## **ZONING CHANGE REVIEW SHEET**

CASE: C814-2014-0110.02.SH

ADDRESS: 7900 Loyola Lane  
Austin, Texas 78724

Project Name and Proposed Use: 7900 Loyola Lane. C814-2014-0110.02.SH. Project: Colony Park Sustainable Community Initiative PUD. A PUD amendment on 208 acres of land to update the Land Use Plan, permitted uses, maximum densities and site development regulations. Related item: Council Resolution # 20230608-053. Amend the Colony Park Plan to make it less prescriptive by: Restructuring the PUD to be more flexible and less prescriptive to better respond to unforeseen opportunities and changing market conditions and to adapt to the 2020 Land Use Plan. Reconfiguring the buffer areas and setbacks for the Critical Environmental Features (CEFs) to create a more cohesive and efficient land use plan. Reducing the number of street sections and bringing them into alignment with the Transportation Criteria Manual. Refining parking requirements to bring them into conformance with current market conditions. Adding Equitable Transit-Oriented Development. Making adjustments to the Open Space Plan, while maintaining a minimum of 41.63 acres (20% of the site) in parks and open spaces. Refin

**Note:** The U2 Draft PUD (Pg. 40) Exhibit K – F. Special Detail has the correct detailed attached. It depicts the solution AE and other COA utilities agreed upon moving AE facilities within the roadway.

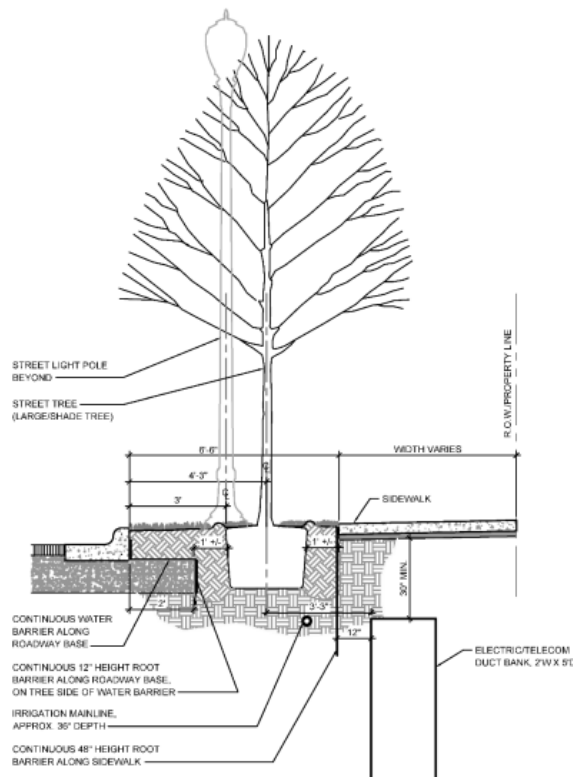
- The U2 Exhibit K edits 9/25/23 and U2 Exhibit K Final 9/25/23 have the incorrect “F. Special Detail” attached. Please replace to match the one shown/provided in the U2 Draft PUD.
- Incorrect detail:
